UNITED STATES PATENT AND TRADEMARK OFFICE

10/520,132

Office Action Summary	Application No. 10/520,132	Applicant(s) WILHELM, STEFAN	
	Examiner John F. Pettitt	Art Unit 3744

DETAILED ACTION

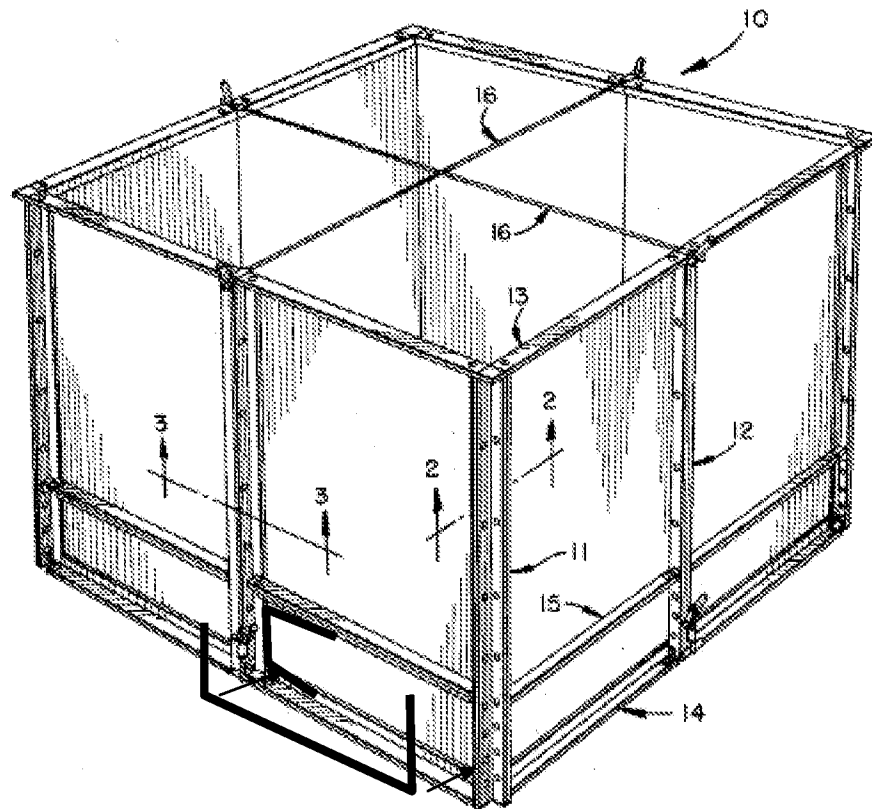
Guillard does not explicitly teach that the cold box is formed by connecting several panels each having a frame and a sheet metal lining. However, forming enclosures of several panels is a well known method of constructing insulation containers, as is taught for example by Carren. Carren teaches an enclosure having several panels (flanges, 19), each having a frame (flanges, such as 16,18) and a sheet metal lining (19; column 3, line 5). Carren teaches that the enclosure permits various sizes to be easily created from the modular components. Therefore, it would have been obvious to one of ordinary skill in the art, at the time the invention was made, to employ the modular enclosure of Carren in providing the cold box of Guillard for the purpose of allowing different sized cold boxes to be created with greater simplicity. Further it is noted that the frames (flanges) of Carren are each made of U-sections that run peripherally on four sides (see figure below, noted that a u-shape is highlighted and

separated from the structure to make it easier for the applicant to see that each frame may be seen to have U-sections that are on at least four sides; it is further noted that the flanges of figures 7-8 also show a U-shape); and the frames (flanges) are provided with diagonal braces (30, 40) mounted on the frames (16-18); the panels are screwed together (bolted), contact points (locations of welds for 40, 30) of the panels (flanges, 19) are sealed by a weld to make the enclosure gas-tight (since welds aide in providing structural integrity and thus provide for sealing enclosure). With regard to claims 2-3, joints (corners) of the panels (frames, 19) on one side wall all have the same distance from one another in the height direction (Fig. 1; panels of the enclosure do not get wider or narrower in the height dimension); additionally noted that Carren shows a square structure. With regard to claim 5, the panels are 2-4 meters (column 4, line 56, 4 by 8 ft). With regard to claim 12, the steel lining (19) of Carren is not explicitly taught to be of a thickness of 3-5mm. However, this is seen to be a routine design choice depending on the structural requirements of the particular cold box desired. With regard to claims 24, 28, the frames (flanges) are reinforced with vertically arranged sections (27, 38; column 4, lines 20-25). With regard to claim 14, the frames being provided with vertical stiffeners in the form of L-shaped steel sections (17).

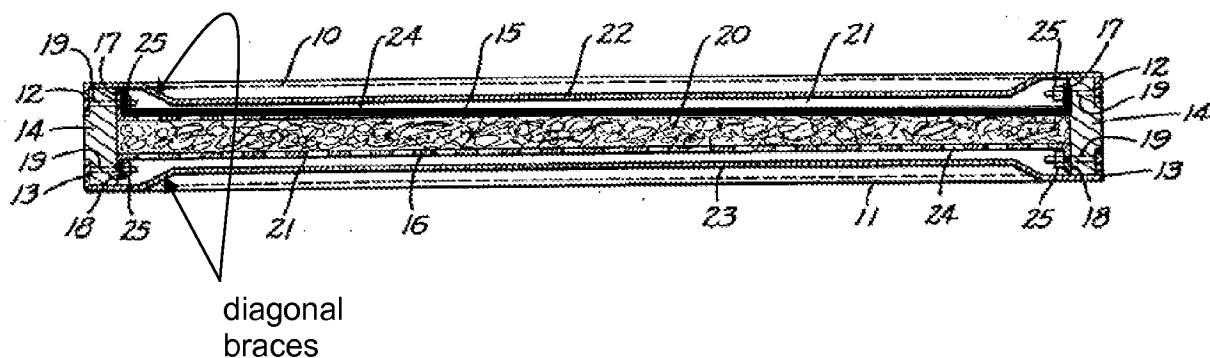
Guillard does not explicitly teach that the cold box is formed by connecting several panels each having a frame and a sheet metal lining. However, forming enclosures of several panels is a well known method of constructing insulation containers, as is taught for example by Nystrom. Nystrom teaches an enclosure having several panels (12), each having a frame (at least flanges) and a sheet metal lining (15, 16, 10, 11). Nystrom teaches that the panel forms enclosures for refrigerated containers (column 1, line 11) and that the panels permit easy construction (column 1, line 30). Therefore, it would have been obvious to one of ordinary skill in the art, at the

time the invention was made, to employ the panels of Nystrom in providing the cold box of Guillard for the purpose of providing an easily constructed well insulated (column 1, line 13) cold box. Further it is noted that the frames (flanges) of Nystrom are each made of U-sections that run peripherally on four sides (see figure below; please note that there are a plurality of U-shapes depending on the cross-section); and the frames (16-18) are provided with diagonal braces (see figure below) mounted on the frames (flanges); the panels are screwed together (bolted), contact points (locations of bolts) of the panels (15-16, 10-11) are sealed by a weld (column 2, line 11) to make the enclosure gas-tight (as welds aide in providing structural integrity and thus provide for sealing enclosure). With regard to claim 12, the steel lining (19) of Carren is not explicitly taught to be of a thickness of 3-5mm. However, this is seen to be a routine design choice depending on the structural requirements of the particular cold box desired. With regard to claims 24, 28, the frames (flanges) are reinforced with vertically arranged sections (14).
